Florida Department of Transportation

PROJECT REEVALUATION

- a. Reevaluation Phase: Design Change
- b. Document Type and Date of Approval: EA/FONSI July 13, 1988
- c. Project Numbers: 256243 1 1851-108  
(If applicable) Financial Project Federal Aid
- d. Project Local Name, Location and Limits: SR 52 from US 19 to I-75, Pasco County, FL
- e. Segments of Highway Being Advanced: From the Suncoast Parkway to I-75
- f. Name of Analyst(s): Gabor Farkasfalvy

FIGURE  
2

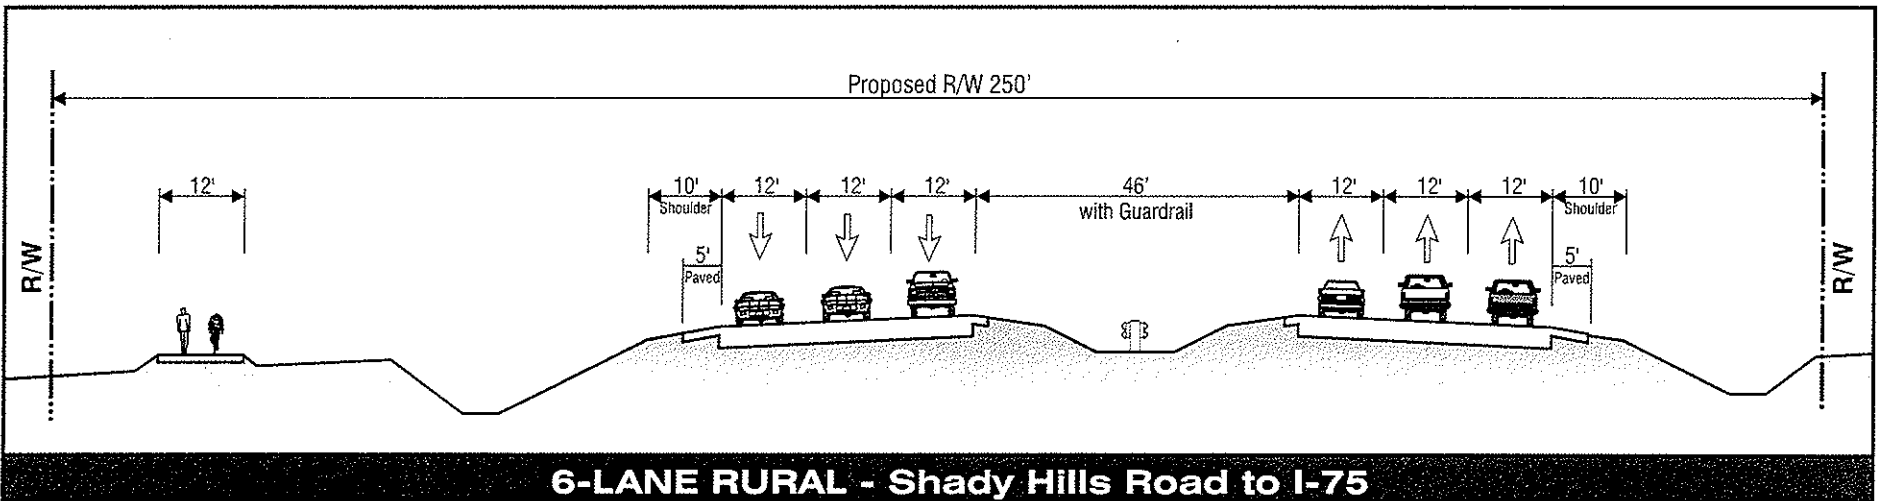
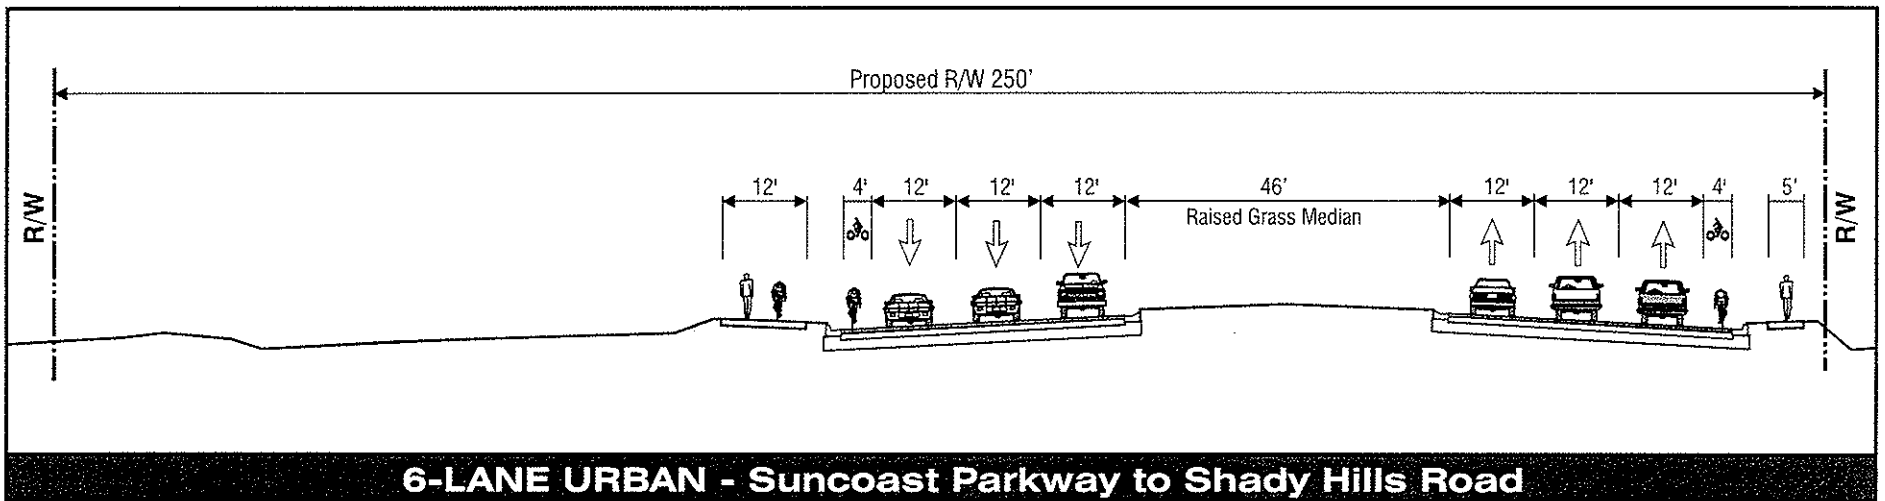
In the EA/FONSI, the typical section proposed for the limits covered by this reevaluation provided a 52-foot median separating two 12-foot lanes for each direction of travel. Ten-foot shoulders would be provided on each side of the roadway. Five feet of the 10-foot width would be paved which would accommodate bicyclists. The total right-of-way width for this typical section totaled 212 feet.

For the proposed design change, from the Suncoast Parkway to Shady Hills Road, the urban typical section provides a 46-foot median separating three 12-foot lanes for each direction of travel. Four-foot bike lanes will also be provided on each side of the facility. A 5-foot sidewalk will be provided along the south side of the roadway and a 12-foot multi-use path will be provided on the north side of the roadway. From Shady Hills Road to I-75, the rural typical section will provide a 46-foot median separating three 12-foot lanes for each direction of travel. Ten-foot shoulders of which 5 feet will be paved will be provided along each side of the facility would accommodate bicyclists. A 12-foot multi-use path will be provided on the north side of the roadway. The total right-of-way width for both of these typical sections is 250 feet.
